RE: 150 Steeles Avenue East and 248, 250 & 314 Martin Street, Milton, Proposed Mixed-Use Development

This memorandum is intended to provide additional information to address the Town’s transportation-related comments dated April 2, 2026 and April 8, 2026, and the Region’s transportation comments dated April 17, 2026, in regard to BA Group’s February 2026 Transportation Considerations Report (“the February 2026 BA Group Report”). We trust that the enclosed memorandum provides the appropriate information requested by the Town. Please feel free to let us know if you have any questions or require any additional information.

1.0 BA GROUP RESPONSES TO TOWN COMMENTS

Appendix A: Updated Functional Road Plan

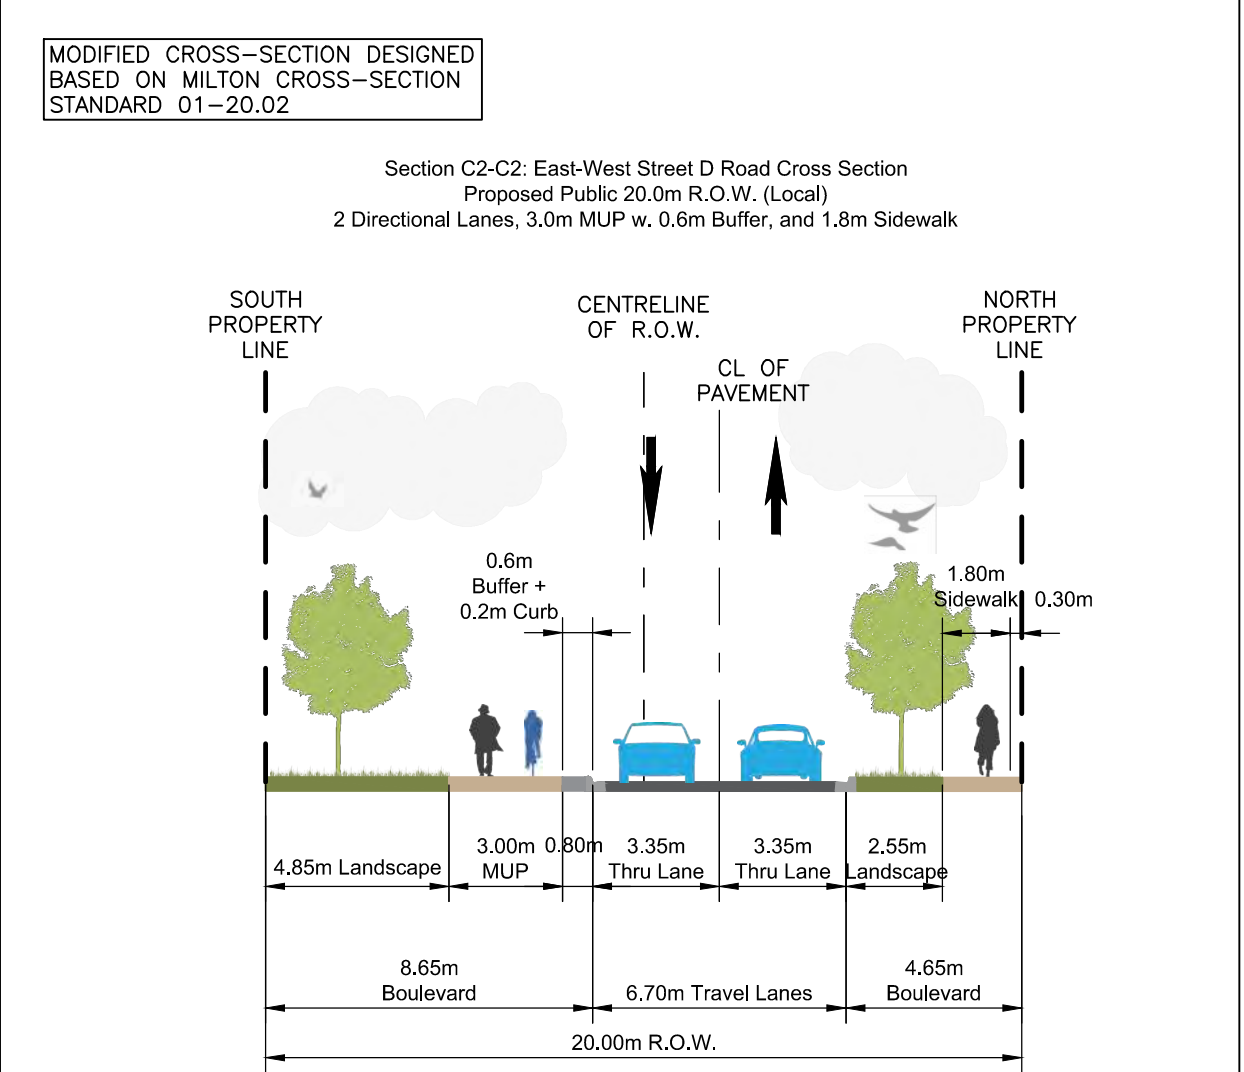
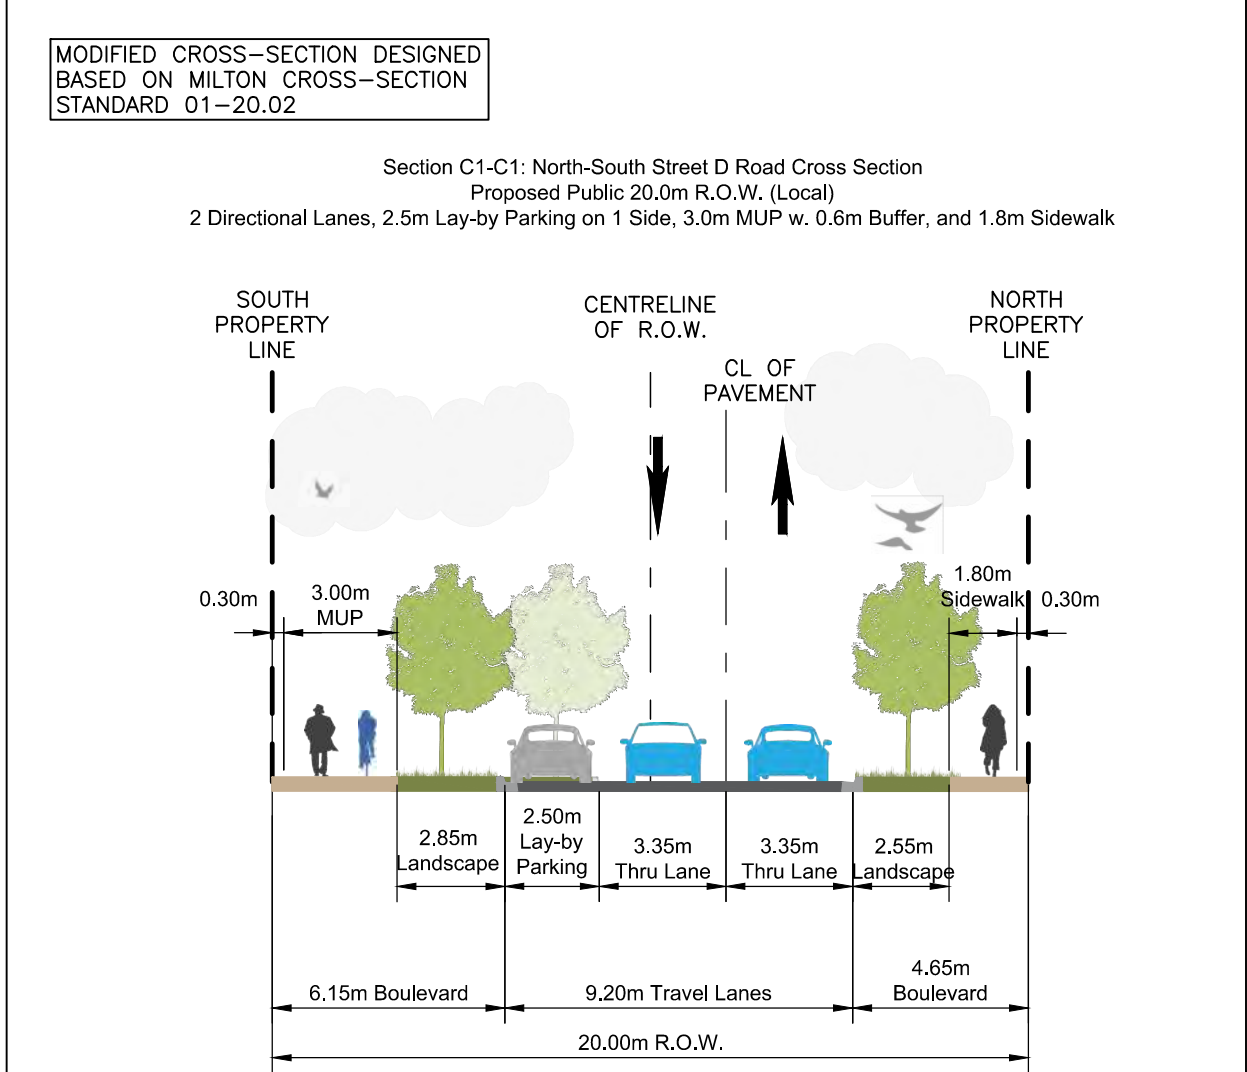
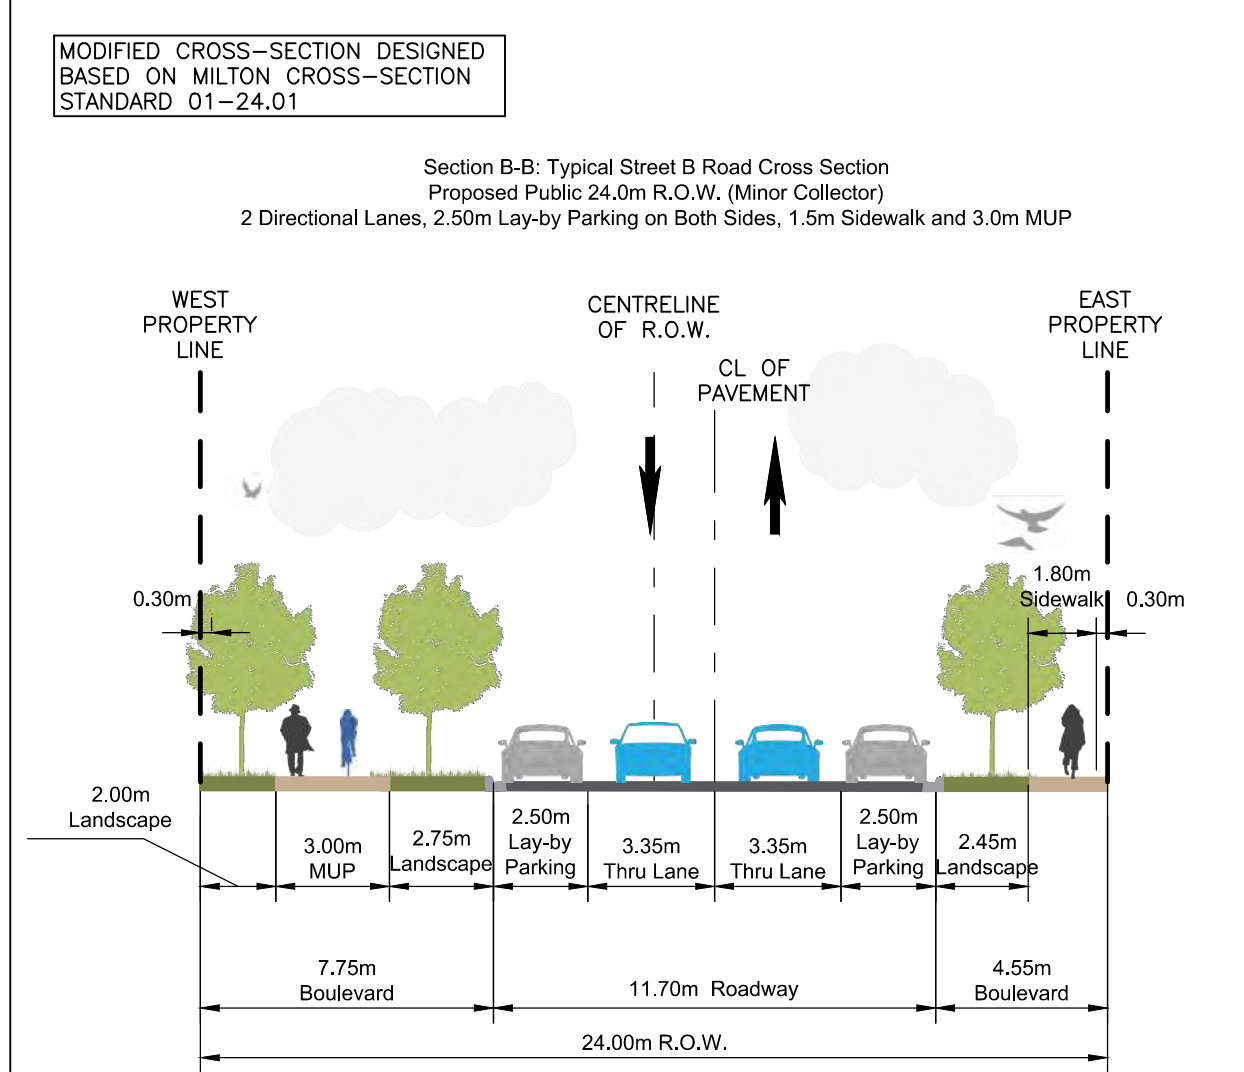
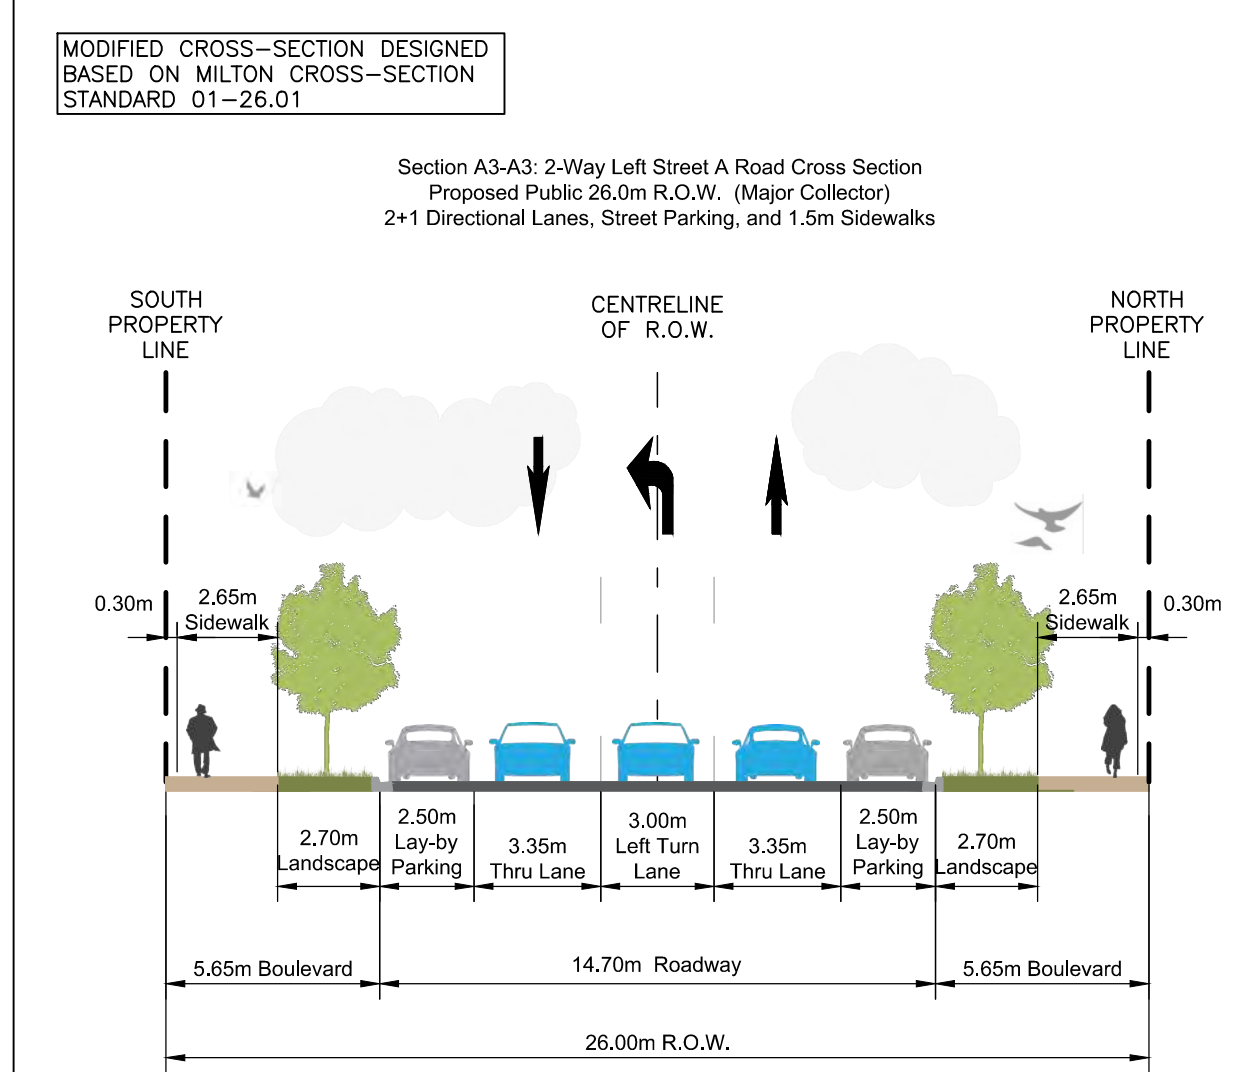
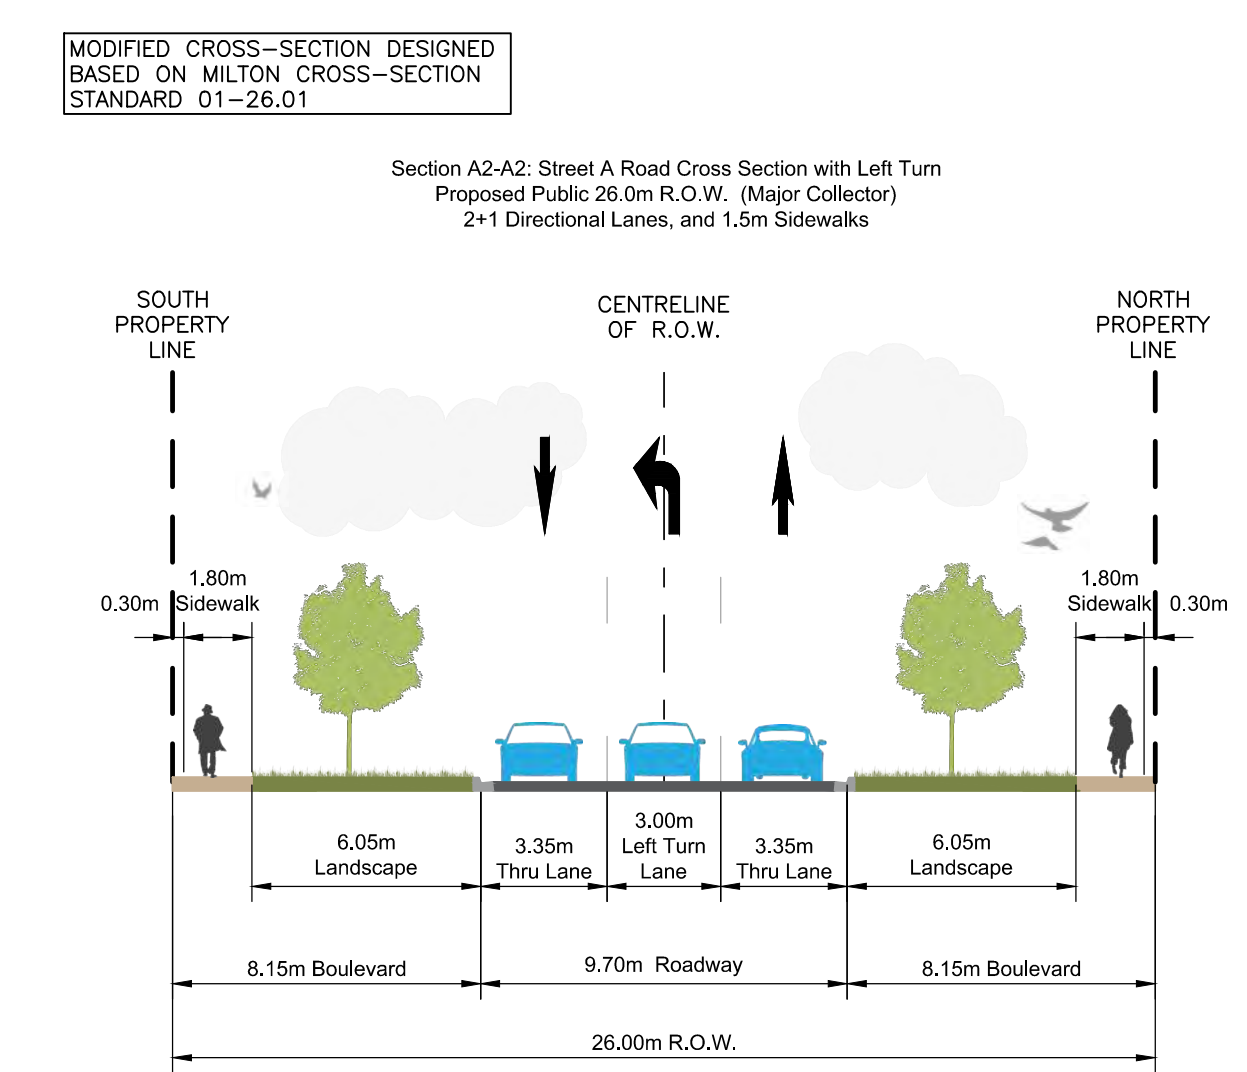
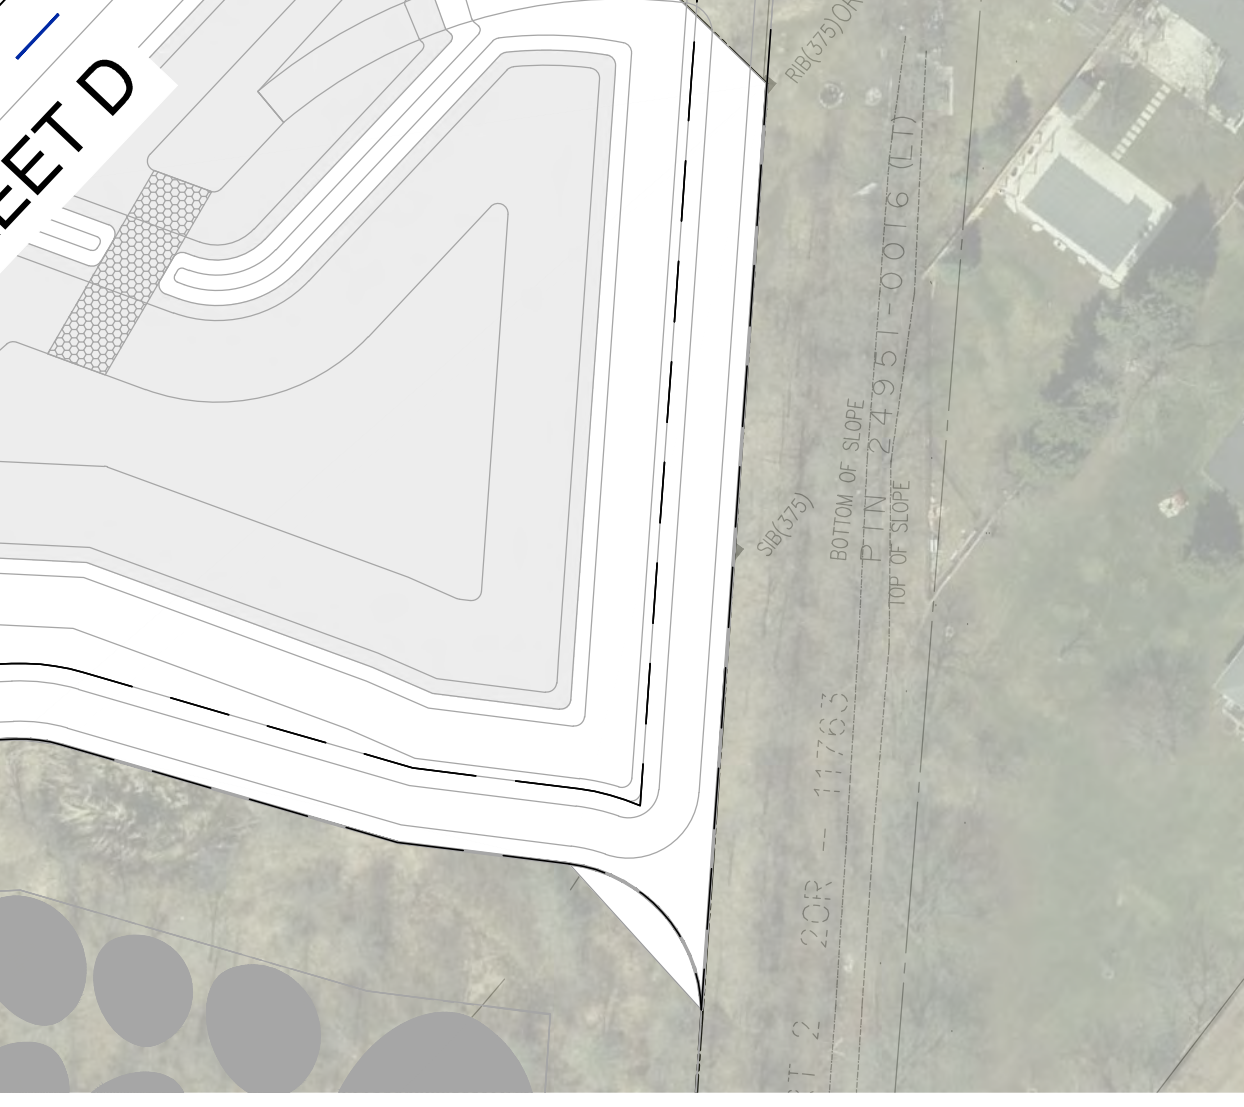
Comment: Please provide appropriate daylighting at all intersections as per the requirements outlined in the Town's Engineering and Parks Standards Manual.

Comment: All internal daylighting must meet Town Standards as per table 1.2.

Comment: Please show daylighting from future ROW limits. Please show the future widening.

Comment: The Notes are to include the curb radius and daylighting for each intersection per Table 1.2 in Part 1 of the Engineering and Parks Standards Manual. There are intersections that do not conform to Table 1.2. Please note that Transportation Planning may provide additional comments under separate cover.

Response: BA Group's functional road plan (attached in Appendix A) has been updated to include appropriate daylighting at all intersections, as per the requirements outlined in the Town's Engineering and Parks Standards Manual. As confirmed by the Region in a November 14, 2025 e-mail, daylighting triangles measuring 15 metres along Steeles Avenue and 15 metres along the proposed Street A and 12 metres along Steeles Avenue and 12 metres along the proposed Street B shall be dedicated to the Regional Municipality of Halton. The e-mail from the Region confirming support for reduced daylighting on Street B at Steeles Avenue, from 15x15 metres to 12 x12 metres, is attached in Appendix B of this memorandum.

Response: BA Group's functional road plan (attached in Appendix A) has been updated to include appropriate daylighting at all intersections, as per the requirements outlined in the Town's Engineering and Parks Standards Manual.

Response: BA Group's functional road plan (attached in **Appendix A**) has been updated to include appropriate daylighting along Martin Street at Street A, as measured from the future ROW limits.

Response: BA Group's functional road plan (attached in **Appendix A**) has been updated to include appropriate daylighting at all intersections, as per the requirements outlined in the Town's Engineering and Parks Standards Manual.
